7.0 Instrumentation and Control Systems

7.1 Introduction

The information in this section of the reference ABWR DCD, including all subsections and tables, and figures, is incorporated by reference with the following departures and supplements.

Figure 7.1-1 ~~SSLC Self-Test System~~ Diagnosis

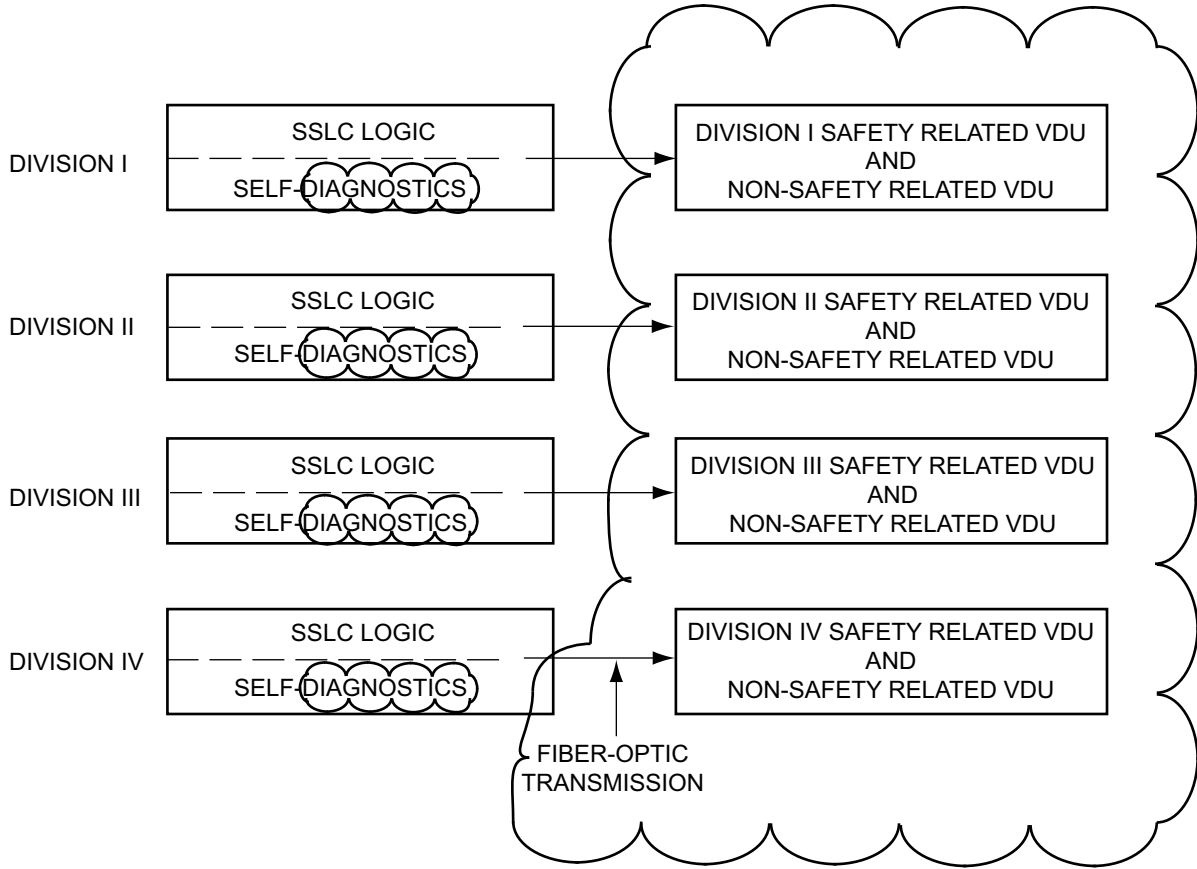
STD DEP T1 3.4-1 (Figure 7.1-1, 7.1-2)

STD DEP T1 3.4-1

Each individual safety-related system utilizes redundant channels of safety-related instruments for initiating safety action. The automatic decision making and trip logic functions associated with the safety action of several safety-related nuclear steam supply systems (NSSS) are accomplished by ~~a four division correlated and separated protection logic complex called the safety system logic and control (SSLC)~~. The SSLC includes multiple redundant divisions, which are separated from each other. The SSLC has four redundant divisions of sensors. Each division of sensors has a corresponding division that determines the trip status of the safety functions relative to the safety function setpoint. The SSLC has four redundant divisions for all actuation functions except for the engineered safety features. The engineered safety features have three divisions, corresponding to the maximum redundancy of the engineered safety features actuated components. Some engineered safety features functions are less than three-fold redundant and are assigned to the appropriate set of redundant divisions. The SSLC multi-divisional complex includes divisionally separate control room and other panels which house the SSLC equipment for controlling the various safety function actuation devices. The SSLC receives input signals from the redundant

- (6) ~~The sixth test is an integrated self test provision built into the microprocessors within the SSLC. It consists of an online, continuously operating, self-diagnostic diagnostics monitoring network, and an offline semi-automatic (operator initiated, but automatic to completion), end-to-end surveillance program. Cross channel comparison of sensor inputs is performed by plant computer functions. Both online and offline functions operate independently within each of the four divisions. There are no multi-divisional interconnections associated with self-testing diagnostics.~~

The primary purpose of the self-test diagnostic function is to improve the availability of the SSLC by optimizing the time to detect and determine the location of a failure in the functional system. It is not intended that the self-test diagnostic function eliminate the need for the other five manual tests. However, most faults are detected more quickly than with manual testing alone.

Figure 7.1-2 Assignment of Interfacing Safety System Logic to SSLC Controllers

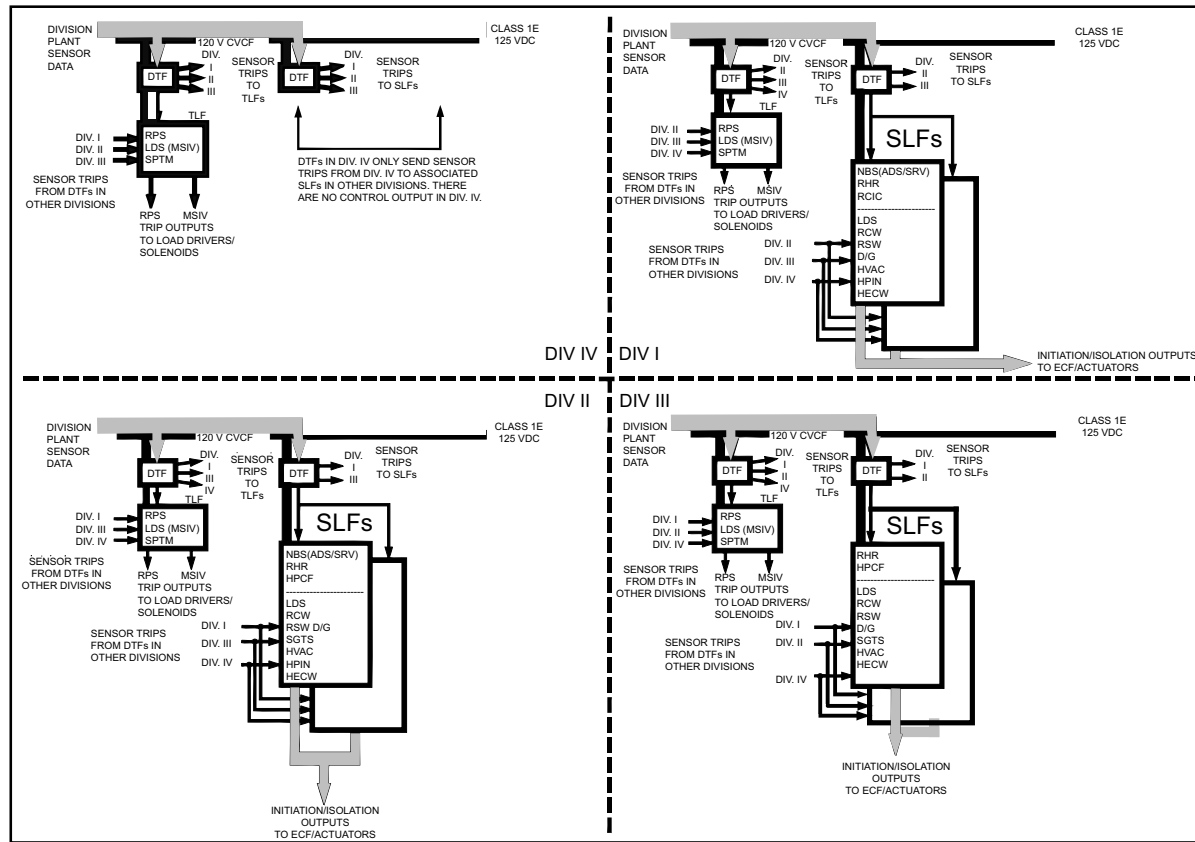
~~Divisional separation is also applied to the essential multiplexing system (EMS), which provides data highways for the sensor input to the logic units and for the logic output to the system actuators (actuated devices such as pump motors and motor operated valves). Systems which utilize the SSLC are include: (1) Reactor Protection (trip) System; (2) High Pressure Core Flooder System; (3) Residual Heat Removal System; (4) Automatic Depressurization System; (5) Leak Detection and Isolation System; (6) Suppression ~~Temperature~~-Pool Temperature Monitoring System; and (7) Reactor Core Isolation Cooling System. The equipment arrangement for these systems and other supporting systems is shown in Figure 7.1-2.~~
